Our Ref: A15223: NVD/JT
Council Ref: 345/2016
RFS REF: D16/1014

**Re: Additional Information response to the NSW RFS
238 Boomerang Drive, Blueys Beach, 2428**

Travers bushfire & ecology (TBE) has been engaged to provide a response to the NSW RFS letter (dated 18 May 2016).

Figure 1 – APZ's for Stage 1

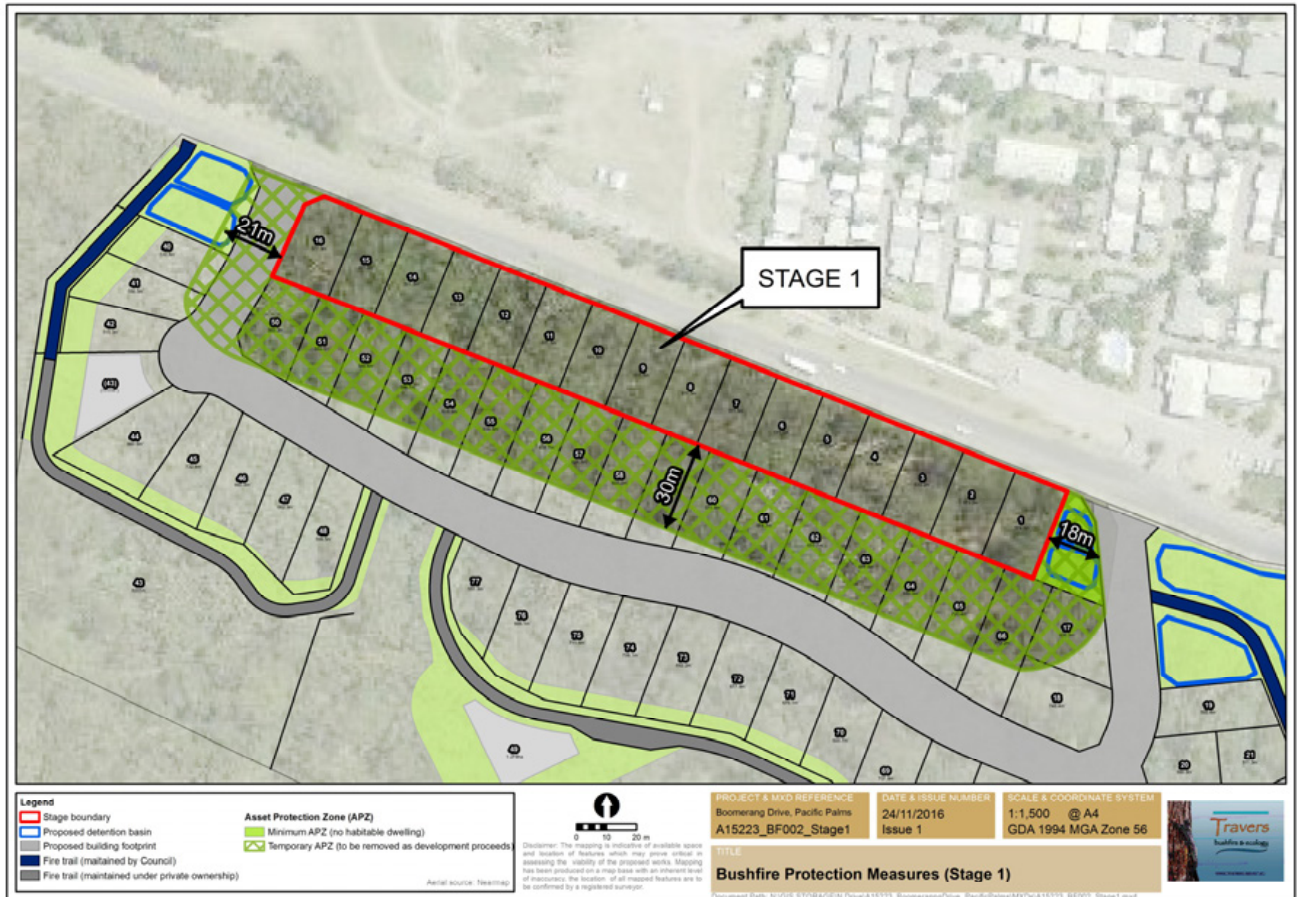
- 3. A separate plan is required for each stage of the subdivision clearly showing proposed asset protection zones for that stage (including temporary asset protection zones over areas of future stages) and staged access arrangements.**

Revised plans have been prepared for each stage of the subdivision to depict the temporary APZ and access requirements (refer Figures 1–3). Temporary APZ's have been applied to those aspects (within the adjoining stages) and can be removed once the vegetation is removed for the proceeding development. APZ's for each stage are detailed on the following pages.

Access for Lots within Stage 1 will via individual driveways onto Boomerang Drive. Access within Stage 2 will be provided via a loop road providing egress to Boomerang Drive in the north away from the direct threat of bushfire. Stage 2 will also include the construction of the central fire trail within Lots 35 & 49. Access to Stage 3 will be provided via a temporary dead end road (with future through road access following the construction of Stage 4). A temporary turning circle is to be provided at the termination of the dead end road (within future Stage 4).

Aspect	Vegetation	Effective land of slope	APZ provided
North	Managed land	N/A	>100m
South	Forest (future Stage 4)	6 degrees up	30m (temporary APZ)
West	Forest (future Stage 3)	Level	21m (temporary APZ)
East	Forest (future Stage 2)	Level

PROJECT & MXD REFERENCE Boomerang Drive, Pacific Palms A15223_BF001	DATE & ISSUE NUMBER 23/11/2016 Issue 1	SCALE & COORDINATE SYSTEM 1:2,000 @A3 GDA 1994 MGA Zone 56
Schedule 1 - Bushfire Protection Measures

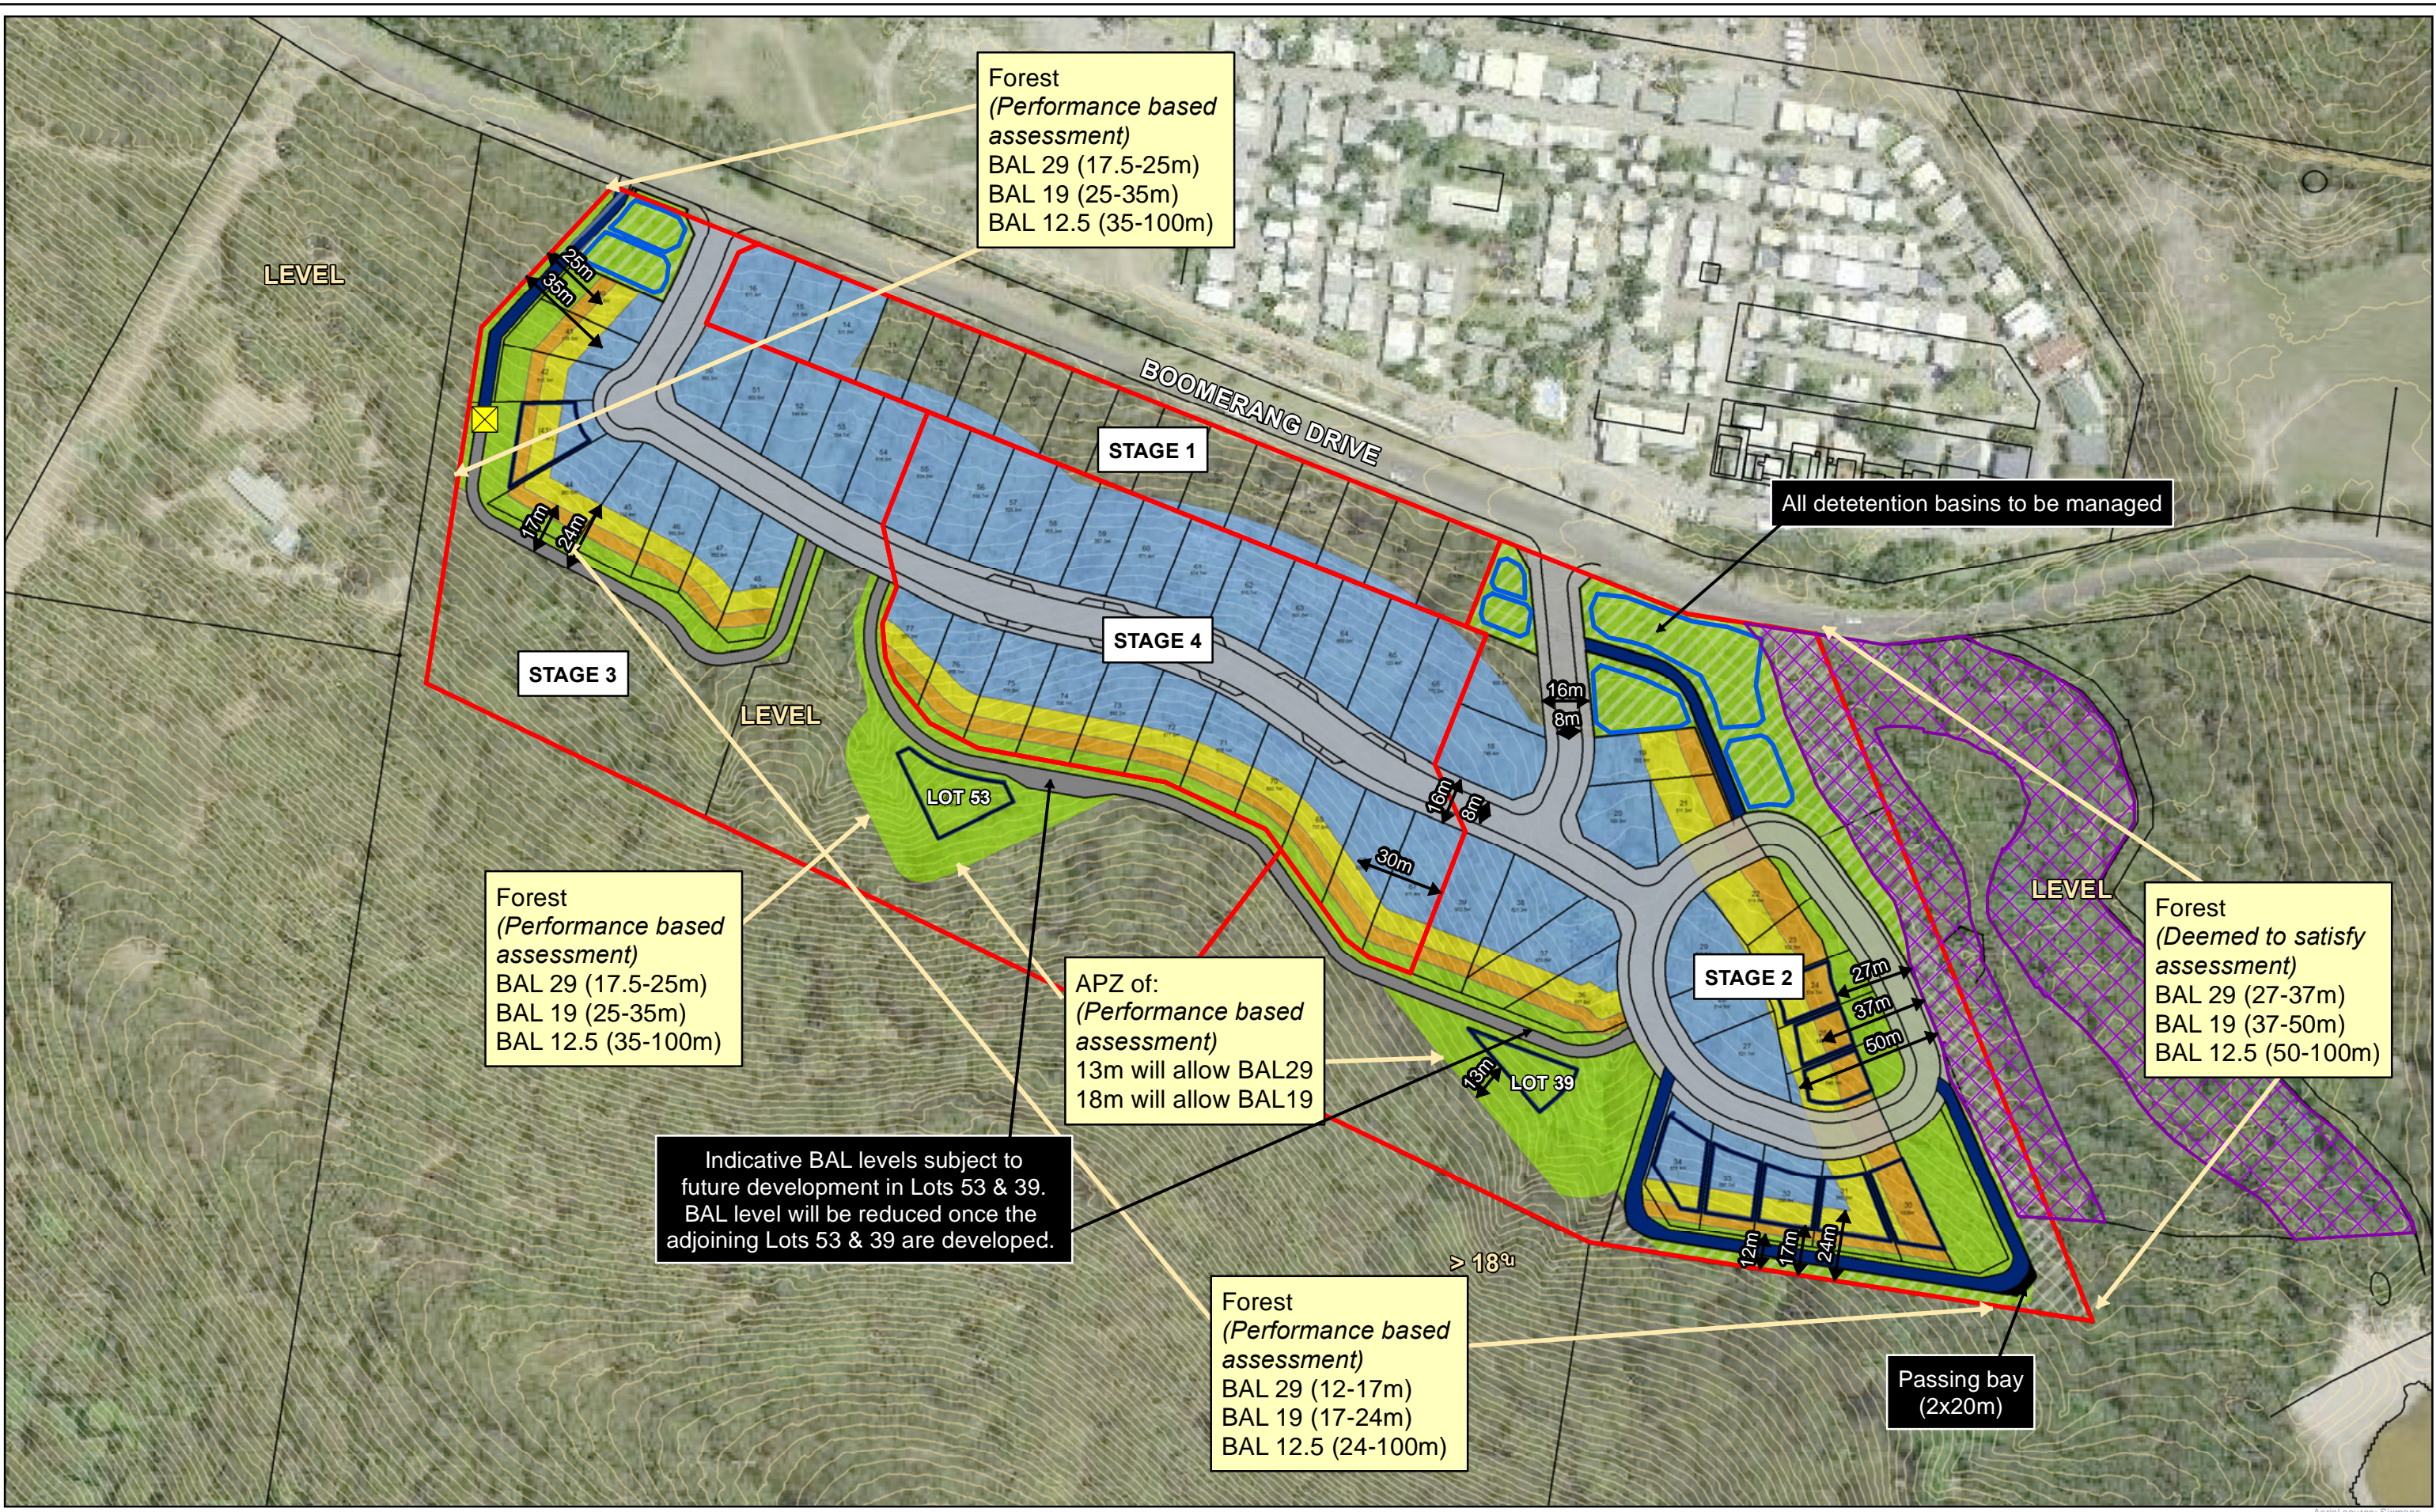
- 1. The proposed subdivision layout does not conform with the requirements of 'Planning for Bush Fire Protection 2006', primarily due to the proposal for a fire trail rather than a perimeter road. 'Planning for Bush Fire Protection 2006' specifically states that a fire trail is not a substitute for a perimeter road and any proposal will need to demonstrate clear benefits over the use of a perimeter road. The provision of a perimeter road needs to be addressed with respect to bush fire protection for the proposed subdivision.***

- 2. The current fire trail proposal is inconsistent with 'Planning for Bush Fire Protection 2006' as it is located over several different lots. Fire trails should be under Council management or located on a community title lot with clear provisions for ongoing management. If a fire trail is proposed and is to be dedicated to Council, evidence of Council's agreement to the ownership and ongoing maintenance of the fire trail is required.**

The exceptional circumstance involved in this proposal is based on the location, type of use and subdivision layout as described in the following dot points. Amendments to the subdivision plan have also been undertaken to further address maintenance requirements of the fire trail, including the dedication of the eastern fire trail into Council ownership and the retention of the western fire trail within Lot 43 and Council drainage reserve (refer Schedule 1 attached).

1. The subdivision plan has been amended so the fire trail is now external to Lots 30–34 & Lots 19 & 20 in land to be managed by Council.
2. The fire trail now extends to the north of Lot 43 to provide a link with Boomerang Drive in the north. This portion of the fire trail (behind Lots 40–42) will also be maintained by Council.
3. The remainder of the western fire trail (extending from Council drainage reserve) is contained within Lot 43 only. The burden for ongoing maintenance is removed from Lot 49.

A plan depicting these amendments is attached to this letter.
